## ADDENDUM #3

**Date Issued: March 27, 2018**

**NEW HAVEN PUBLIC SCHOOLS  
SCHOOL CONSTRUCTION PROGRAM**

4 EXTERIOR DUCTWORK DETAIL  
1/4" = 1'-0"

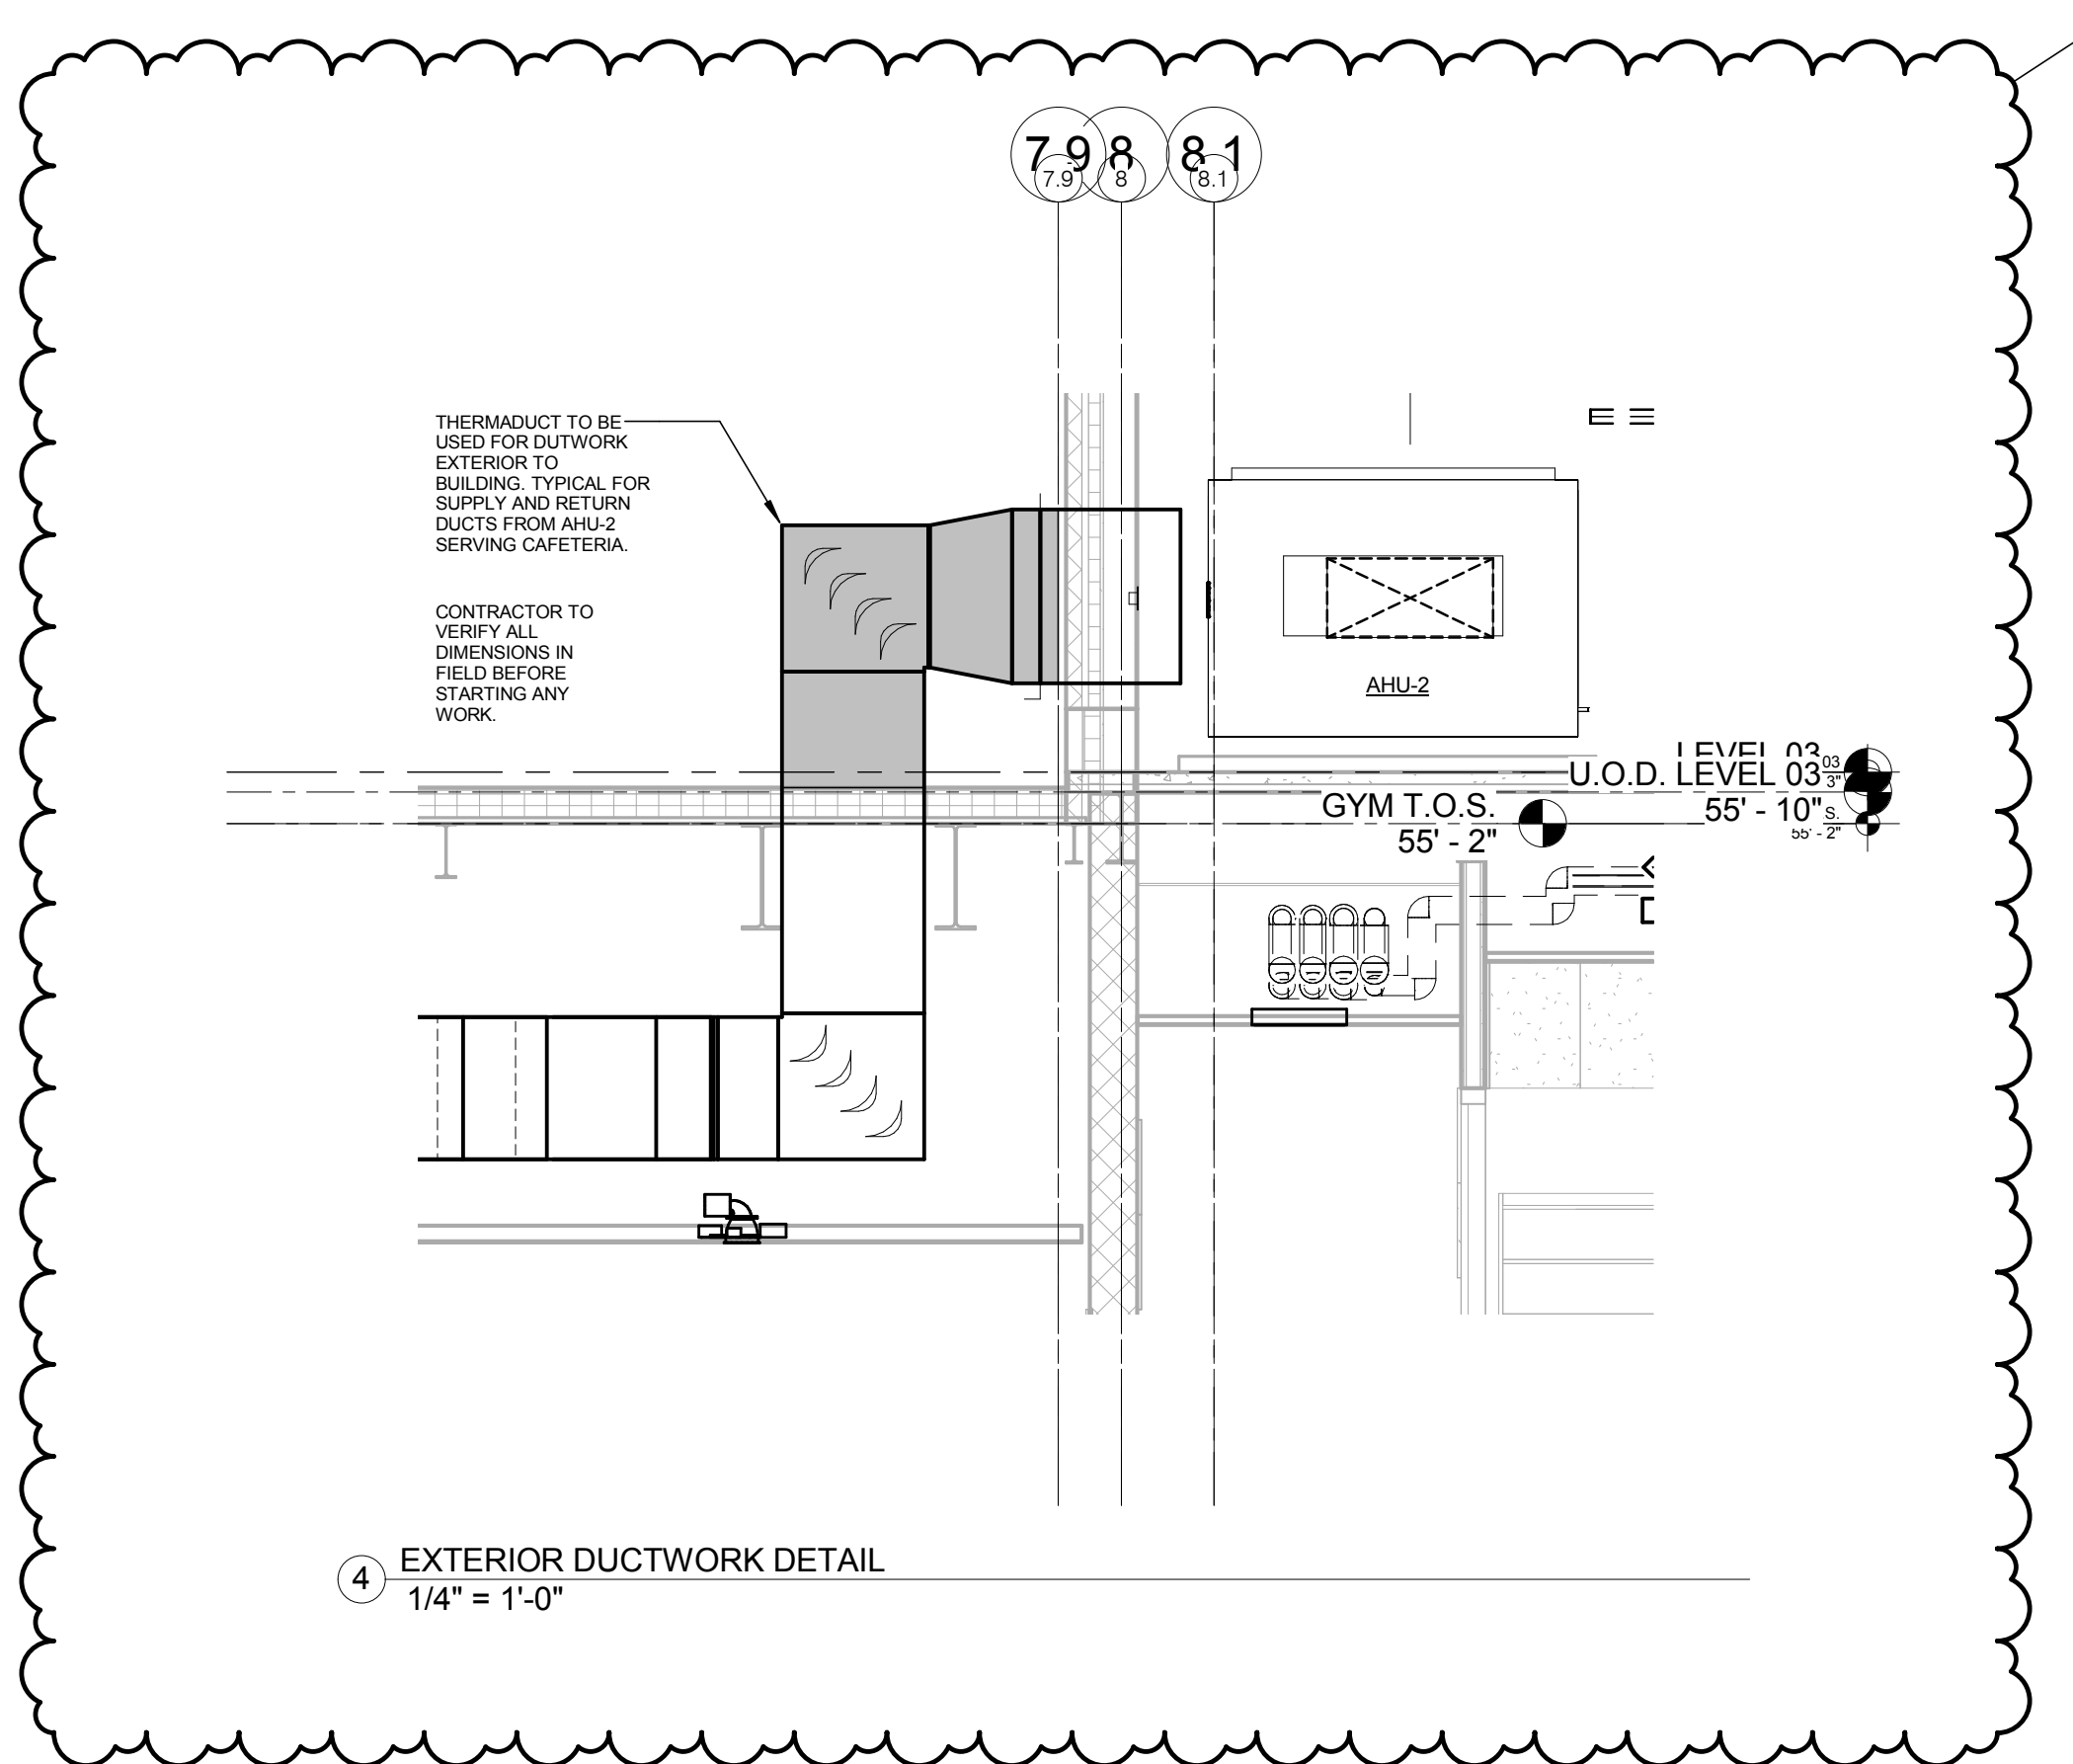
8. **CLARIFICATION:** Section 4/M-300 was added to drawings to clarify the extent of work for Thermaduct exterior ductwork system.
9. **CLARIFICATION:** Hot water supply and return piping serving third floor was changed to 4” in lieu of 6” as shown on construction documents.

28). [Ref: M-300](#) - Would it be possible to provide an elevation view of the Therma duct system for the ductwork attaching to SA-AHU-2-S & SA-AHU-2-R. Duct is shown in plan view on drawings M-300 and MEP-142, but after reviewing the architectural drawings and other mechanical drawings it is not 100% clear how much Therma duct is needed. An elevation view would help clear this up for sheet metal vendor pricing and sheet metal labor.

28). Ref: M-300 - Would it be possible to provide an elevation view of the Therma duct system for the ductwork attaching to SA-AHU-2-S & SA-AHU-2-R. Duct is shown in plan view on drawings M-300 and MEP-142, but after reviewing the architectural drawings and other mechanical drawings it is not 100% clear how much Therma duct is needed. An elevation view would help clear this up for sheet metal vendor pricing and sheet metal labor. - **CES Response: Refer to Addendum #3.**
